June 16, 2023

Namrit Uppal  
20 Avenue project team  
City of Surrey

## Re: Feedback on Phase 1 Design

**Figure 1: Design of roadway near realigned Croydon Drive:**

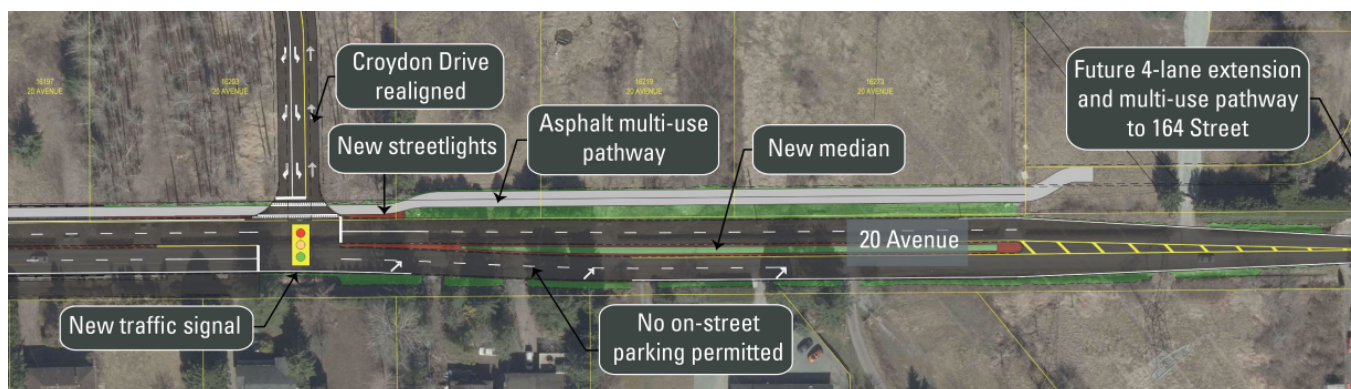
People cycling eastbound will need to cross back to 20 Avenue at this intersection and take a lane until a future 4 lane extension is made east of Croydon. There do not appear to be any facilities provided for people cycling to perform this action. Has the project considered how people cycling are to perform this action? Should a bike box be provided and the stop lines pulled back or should a bike crossing be provided? Will people cycling be able to trigger the traffic light? The pathway on the north side becomes a dead end east of Croydon Drive and doesn't appear to be even connected to the roadway for people cycling westbound.

Figure 3: Typical Cross Section:

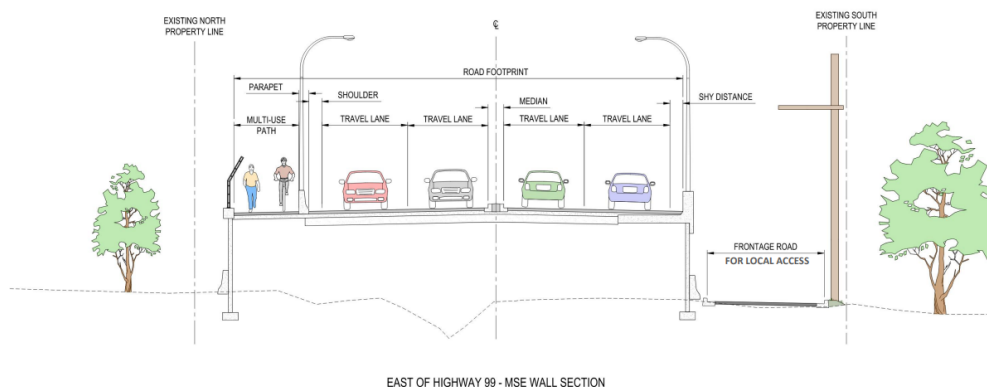
The typical section at the overpass is planned to be 2.5 m wide which is less than the minimum width for a multi-use pathway according to Transportation Association of Canada guidelines which recommend a minimum width of 2.7 m with no horizontal clearance restrictions. As there are barriers on both sides of the pathway horizontal clearances should be considered for when two people cycling pass each other. The operating envelope of a person cycling is 1.4m so considering horizontal clearance the pathway should be at minimum 3.8 m wide. Note that the BC Active Transportation Guidelines<sup>2</sup> recommend a minimum width of 2.7m for constrained pathways with a horizontal clearance of 0.6m. This would mean that the minimum width should be 3.9 m wide. The project only seems to constrain the width of the path due to budget concerns as it is not constrained by the property boundary. We note that the roadway is constructed for vehicles with horizontal clearance between the barriers and the travel lanes but horizontal clearance for pathway users is not considered. Why is the City following guidelines when it comes to building for vehicles but ignores those same guidelines when it comes to constructing facilities for people walking and cycling? The fence shown also leans into the pathway space and doesn't appear to follow the vertical clearance guideline either. Due to the lack of width people cycling are at a risk of striking the lamp post or fence when passing another person cycling. Will the design include a bicycle railing to prevent handlebar striking of the fence and lamp posts?

Figure 9: Design at King George:

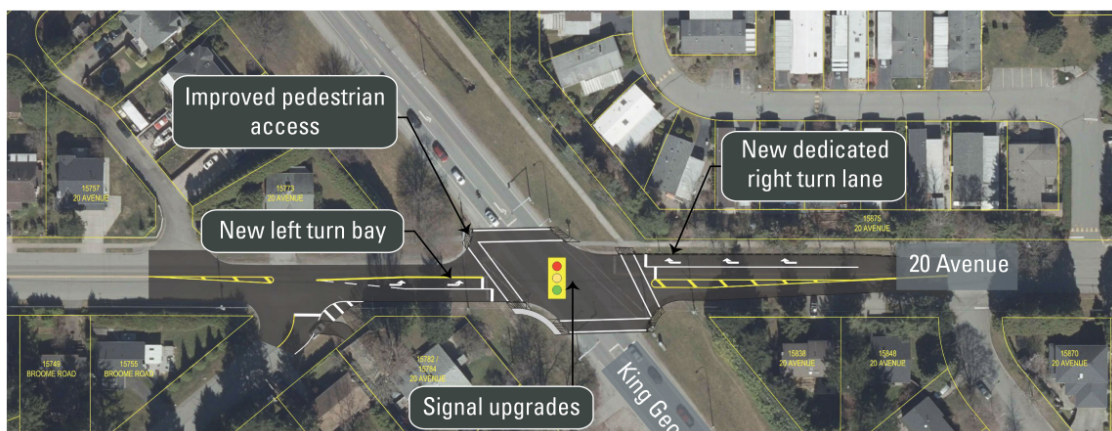
The King George intersection does not provide any improvements for cycling. We are assuming that cycling improvements will be conducted in phase 2, however these improvements could be done in Phase 1 if the intersection is being rebuilt. Will there be protected cycling infrastructure built here?
